CHP's Potential to Reduce GHG Emissions in California

Evaluation of a June 2013 CRRRI Conference Paper

Figure 3 - Summary Charts from Choudhary et al's Paper

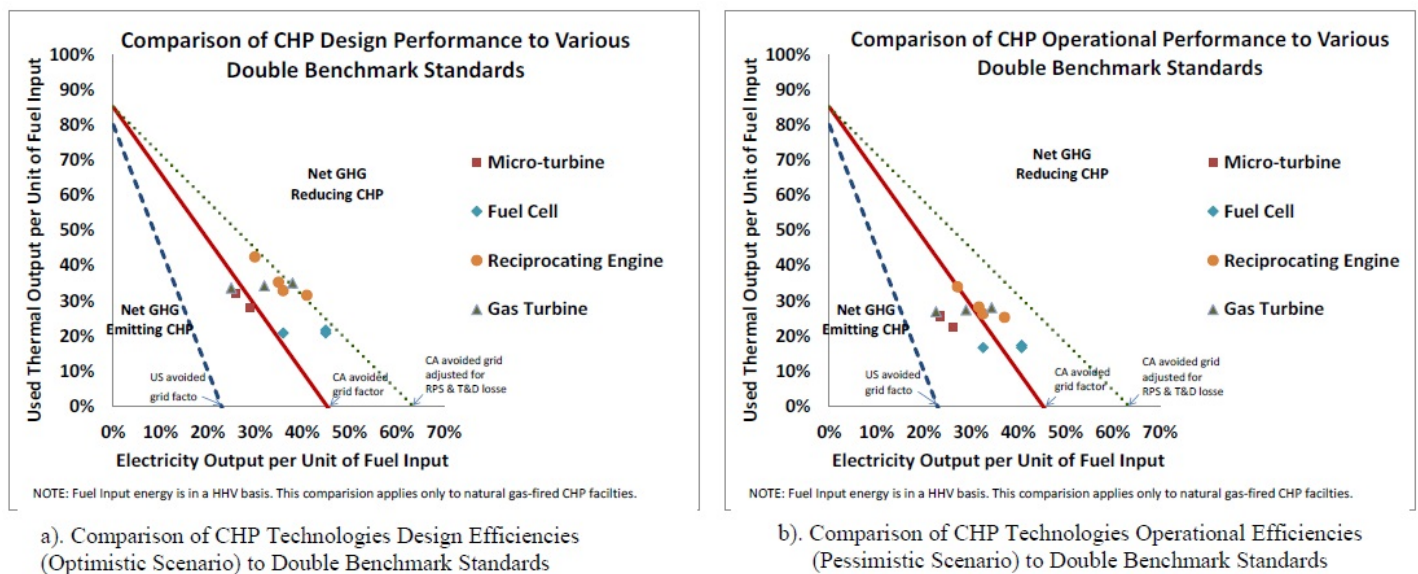
Figure 3 shows the final "optimistic" and "pessimistic" summary charts in Choudhary et al's paper (referred to as Figure 6 in the paper). This double benchmark presentation is a very compact way of presenting the data but is not entirely transparent because it uses efficiency as a surrogate for an emissions comparison instead of directly expressing the absolute emissions or emission rates from each system. The efficiency factors are used with several additional details and supporting assumptions that can be found in the original Choudhary et al paper. There are three critical sets of assumptions that drive the results:

ICF finds some of Choudhary et al's assumptions regarding CHP system performance (i.e., thermal utilization, heat rate degradation, RPS adjustment to CA's 2020 grid heat rate, 85% boiler efficiency) are not consistent with our experience with CHP systems installed in the U.S. and all have the effect of reducing the benefits of CHP relative to SHP. In order to show this more clearly, ICF uses an emissions-based comparison, which we believe is more transparent and applicable to a GHG analysis than an efficiency-based comparison. We present the comparison using emission rates in metric tonnes of CO₂ per megawatt-hour (tonnes/MWh) across various technology types and system sizes.

Figure 7 - CO₂ Emission Rate Comparison for Combined versus Separate Heat and Power
2020 CA Grid with 80% Thermal Utilization and 85% Avoided Boiler Efficiency

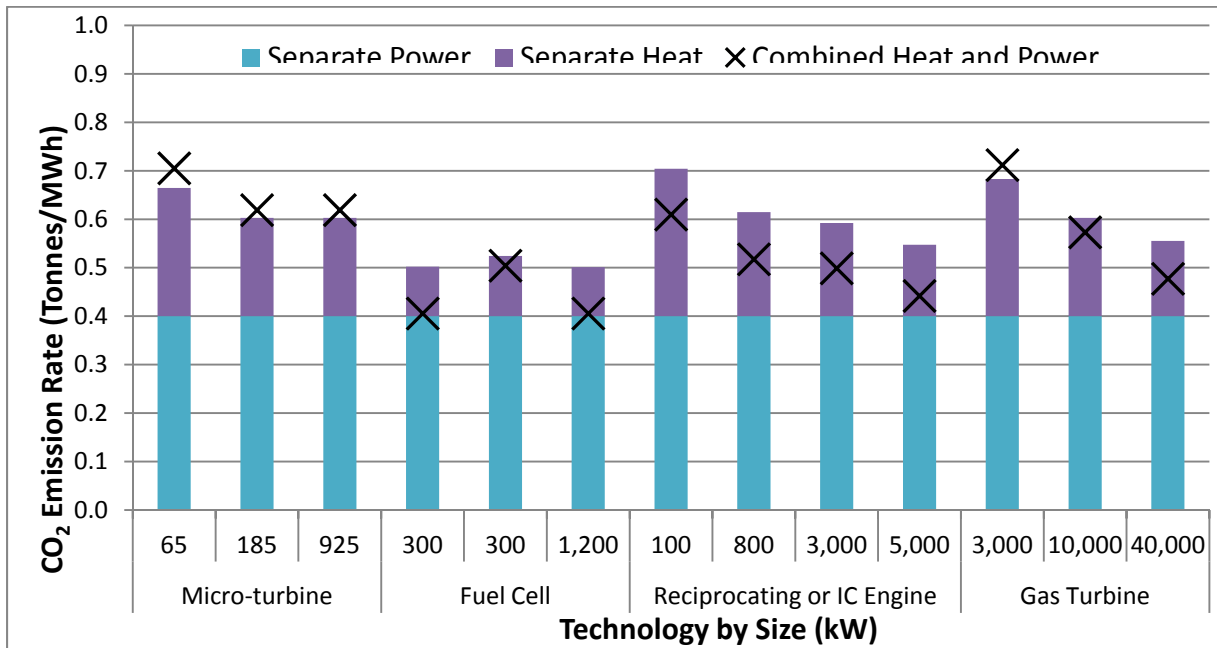
Figure 7 presents the emissions version of Choudhary et al 's paper, Figure 6, the Optimistic Case for CA 2020 avoided grid. Overall, most systems are still net GHG-reducing despite the relatively low thermal utilization of 80% applied to all systems, the relatively high avoided boiler efficiency of 85%, and the comparison to a projected 2020 California grid emission factor. Four of 13 CHP systems (three microturbine and one gas turbine) are net GHG-emitting ("X"s above the stacked bars).

Figure 8 - CO₂ Emission Rate Comparison for Combined versus Separate Heat and Power
2020 CA Grid with 64% Thermal Utilization and 85% Avoided Boiler Efficiency

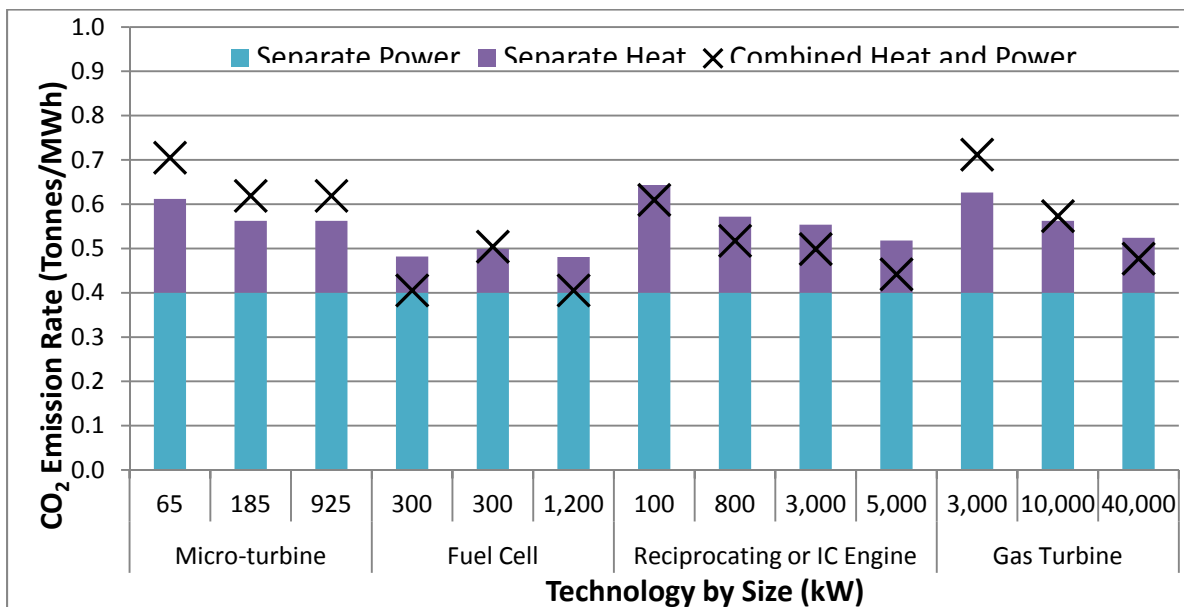
Figure 8 shows the Choudhary et al 's "pessimistic" case (Figure 6), in emissions format. This case has a lower thermal utilization. This means that the CHP system is generating more thermal energy that is not being used, translating to lower levels of thermal energy requirements from the separate thermal system and therefore lower "separate heat" emissions. With these pessimistic assumptions, approximately half of these CHP systems are net GHG-emitting and half are net GHG-reducing. The higher assumed boiler efficiency also reduces the calculated SHP emissions.

**Figure 9 - CO₂ Emission Rate Comparison for Combined versus Separate Heat & Power
2020 CA Grid with 90% Thermal Utilization and 80% Avoided Boiler Efficiency**

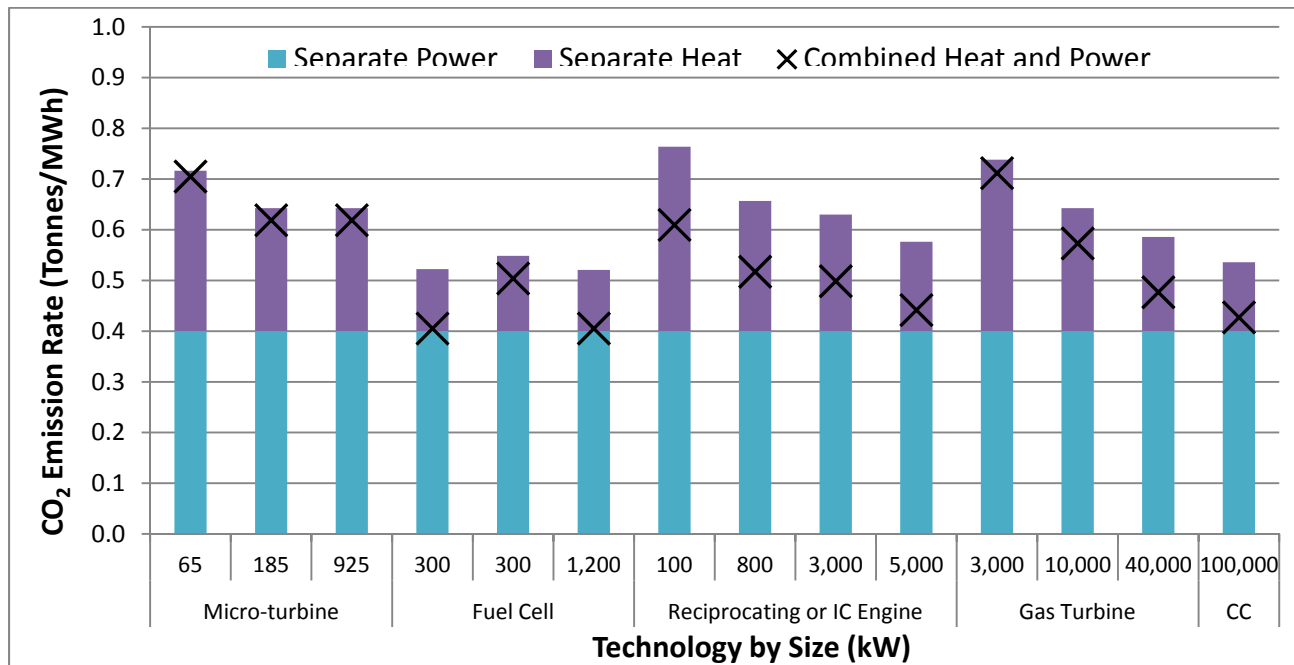
We now explore two additional charts showing CHP versus SHP GHG emission rates using a series of assumptions more consistent with ICF's CHP experience. We have also added one additional bar to show the performance of a combined cycle CHP facility, which makes up a large share of the capacity in California. Figure 9 is comparable to Choudhary et al 's cases with more typical assumptions: 80% boiler efficiency and 90% thermal utilization. With these assumptions, the CHP systems are net GHG-reducing in all cases with a 2020 CA grid factor, and in most cases, considerably below the SHP emissions rate. Comparing Figure 9 with Figures 7 and 8, more typical boiler efficiency and thermal utilization assumptions translate to net GHG-reducing CHP systems across all system sizes analyzed.

Figure 10 - CO₂ Emission Rate Comparison for Combined versus Separate Heat & Power
2020 CA Grid RPS and T&D with 90% Thermal Utilization and 80% Avoided Boiler Efficiency

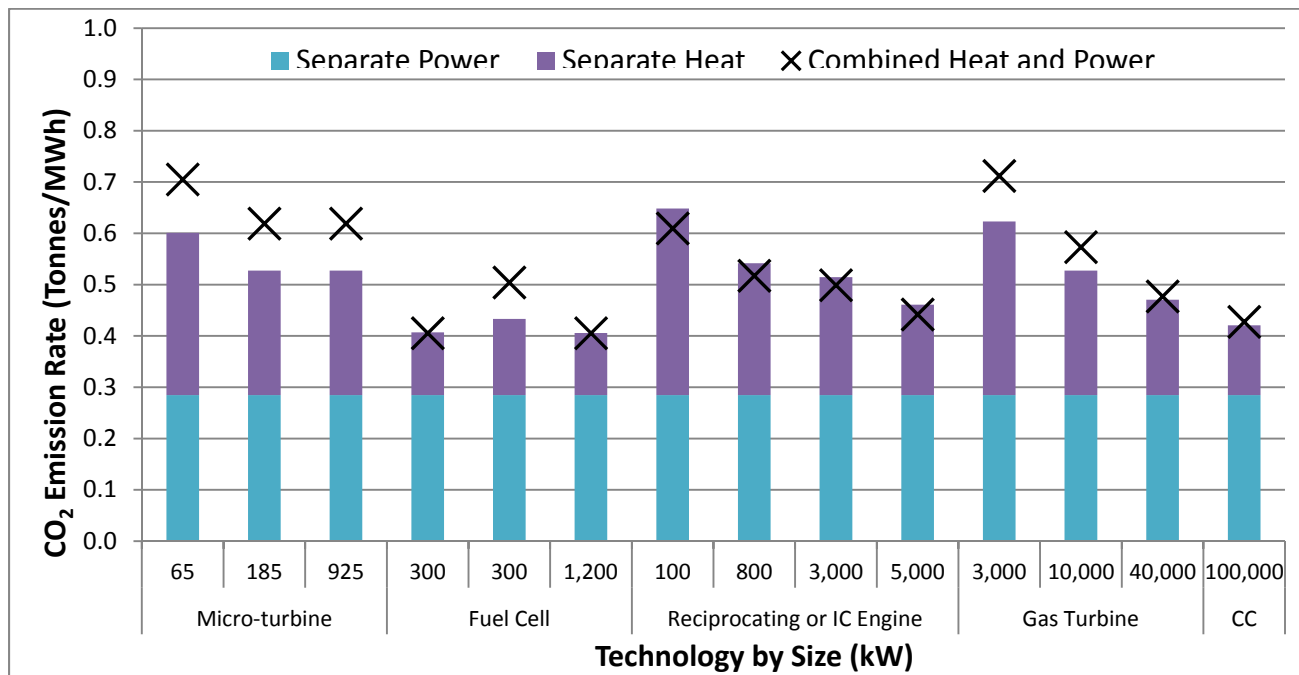
Figure 10 shows the effect of explicitly accounting for the California RPS and reduced T&D losses for behind-the-meter CHP systems by discounting the grid emissions factor. Figure 10 is the same as Figure 9 except that the CA 2020 emissions are discounted to account for California's RPS (33% renewables by 2020) and increased to account for T&D losses (6.9%). This assumes that behind-the-meter CHP will avoid T&D losses but will be penalized for not being part of the RPS, which only applies to power sold by utilities. This adjustment has a large impact on the comparison of emission rates. All reciprocating engines are still net GHG-reducing, as are some fuel cells and large gas turbines, but many systems are now net GHG-emitting due to the lower implied grid emissions rate.

There are several caveats to this analysis of the implications of the RPS on grid emissions.

- It only applies to behind-the-meter CHP systems that are not selling any power to the grid. As described above, the majority of CHP generation is from larger systems that do sell to the grid and do not meet this description.

- It is not clear that on-site generation will actually affect implementation of the RPS in a direct one-to-one proportion (i.e., for every MWh of electricity generated, there is one-third MWh of renewables discounted). Utilities will purchase (and are purchasing) renewable generation in advance and in large blocks that will not likely be fine-tuned to small changes in on-site generation. Thus the actual impact of on-site generation may be less than indicated by the RPS discount assumed in the Choudhary et al analysis. This may be a topic for additional analysis based on the actual implementation of the RPS.

- Finally, The CA 2020 analysis seems to assume that that gas combined cycle units are on the margin at all or most times (with a marginal heat rate of 7,537). However, it may be that less efficient peakers will be on the margin much of the time, especially when the RPS is implemented, in order to follow variable load from solar and wind resources. A recent study of different RPS scenarios⁶ shows combustion turbines and gas steam plants being on-line during all hours of many typical days, which would suggest a higher marginal heat rate and emission rate.
